**BEFORE THE PUBLIC UTILITY COMMISSION
OF OREGON**

LC 62

2015 Integrated Resource Plan.

Opening Comments

Figure 3--PacifiCorp IRP Page 149 - NG Prices in Core Case Definitions

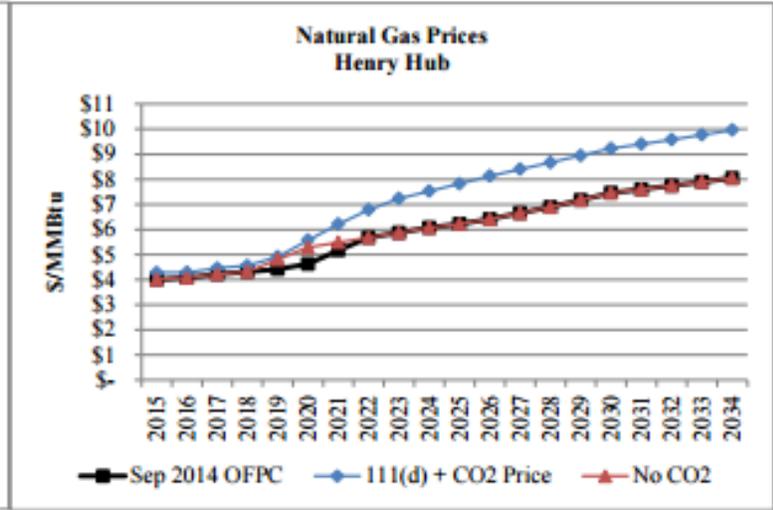
PacifiCorp’s gas price forecast as depicted on Volume I pages 149 and 168 compares favorably with gas price forecasts from the federal Energy Information Agency (EIA) and SNL, as shown in Figures 3-5 in Attachment A. PacifiCorp’s gas price forecast also compares favorably with the forecasts used by Avista (Fig. 6) and Northwest Natural (Fig. 7) in their 2014 IRPs, also as shown in Attachment A.

As a result, Staff concludes that PacifiCorp’s 2015 IRP gas price forecast is reasonable for planning purposes.

Chapter 7 – Transmission Modeling and Portfolio Evaluation Approach - Regarding Figure 7.2 of Volume I of PacifiCorp 2015 Integrated Resource Plan (IRP), where the Company provided a figure of the following Transmission System Model Topology:

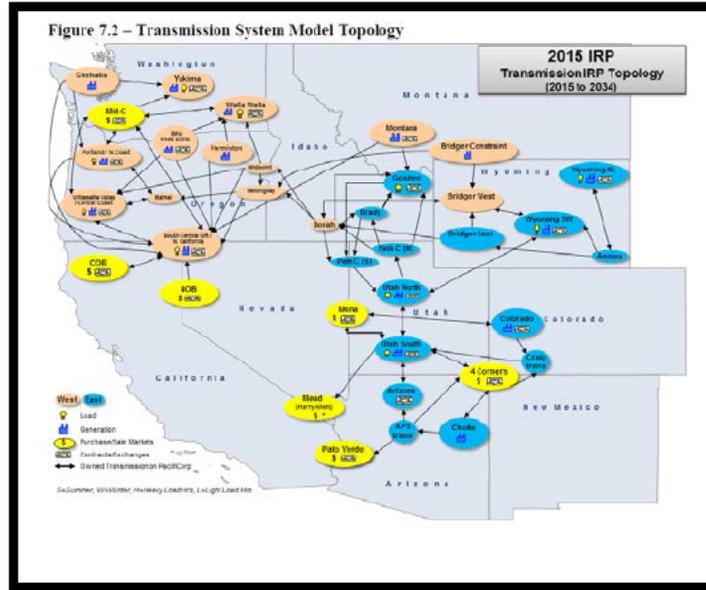
- (a) Provide a list of the **transmission paths** referenced above including each transmission path’s transfer capability (if possible, please provide the requested information in a table);
- (b) For each **transmission path** provided in part (a) of this data request, please indicate what physical transmission lines are represented by such transmission path. Please provide the most relevant characteristics of the indicated physical transmission lines

- (e.g., name of the transmission line, voltage, physical transfer capability, rated transfer capability); and
- (c) For each **transmission path**'s transfer capability provided in part (a) of this data request, please provide an explanation of how such transfer capability was estimated, including the amounts of, for example, the transmission rights of PacifiCorp's merchant function, the transmission rights of PacifiCorp's transmission function, the transmission rights of other regional providers, etc.;

- (a) Please refer to the confidential data disks that accompanied the Company's 2015 Integrated Resource Plan (IRP), filed with the Public Utility Commission of Oregon (OPUC) on March 31, 2015; specifically:

- (b) Please refer to Confidential Attachment OPUC 7.
- (c) Each transmission path's transfer capability provided in the Company's response to subpart (a) above is based upon PacifiCorp's merchant function's purchased or allocated transmission rights from transmission providers unless:
1. noted otherwise in column K of the file referenced in the Company's response to subpart (a) above, or
 2. is a projected allocation from future Energy Gateway transmission projects as noted in column C (column C provides reservation numbers associated with the transmission rights the Company's merchant function owns).

Regarding Figure 7.2 of Volume I of PacifiCorp 2015 Integrated Resource Plan (IRP), where the Company provided a figure of the following Transmission System Model Topology:

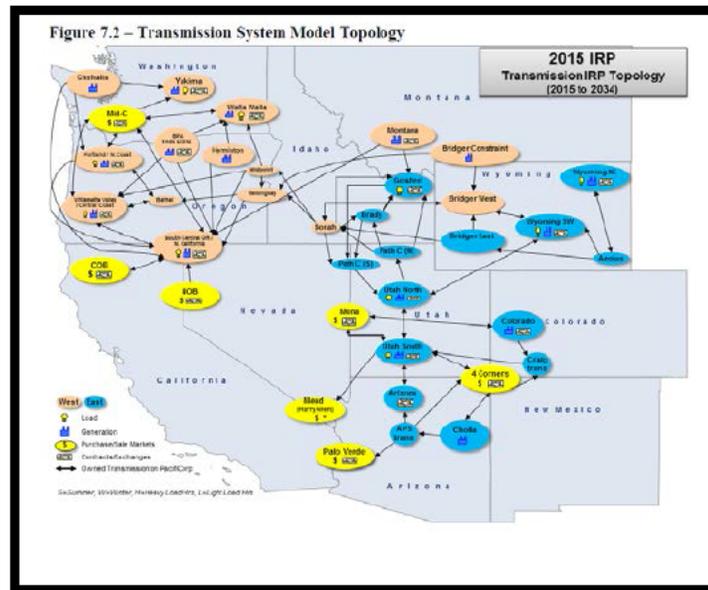
- (a) Has the Company assumed maximum available FOTs for the hubs other than the hubs represented in Table 6.15 above? By “other hubs,” Staff refers to the hubs represented in the above Transmission System Model Topology figure such as Mead, Palo Verde, 4 Corners. If “yes,” please provide the maximum available FOT transaction quantities

for such other hubs; if "no," please provide a comprehensive explanation of the Company's response, including an explanation of why such other hubs were modeled in the Transmission System Model Topology; and

- (a) Front Office Transactions (FOT) are not included at Mead, Palo Verde (PV), and Four Corners (4C) due to transmission constraints. These market locations are included to reflect system balancing transactions.
- (b) The limits of FOTs at various hubs are not solely determined based on whether the Company has executed transactions historically. Please refer to the Company's response to OPUC Data Request 11.

Chapter 7 – Front Office Transactions (FOT) in Modeling and Portfolio Evaluation Approach - Regarding page 134 of Volume I of PacifiCorp 2015 IRP, where the Company represented:

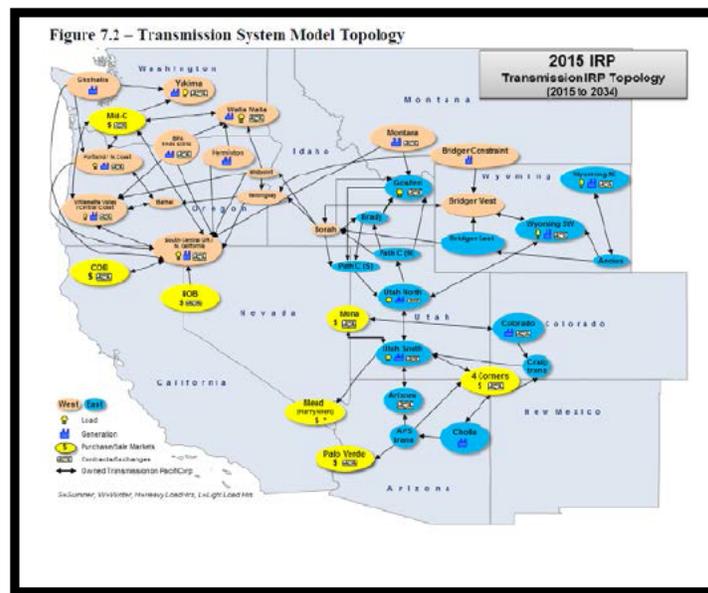
For each market hub referred to above (i.e., Mid-C, COB, NOB, Mona, Mead, Palo Verde, and 4 Corners), please provide:

- (a) Historical data is not modeled in the Integrated Resource Plan (IRP) studies. Please refer to Confidential Attachment OPUC 12 -1, which provides short-term firm (STF) market purchases that were one month or longer in duration and Confidential Attachment OPUC 12 -2, which provides STF market purchases that were shorter than one month. The transactions were for deliveries in January 2010 through December 2014.
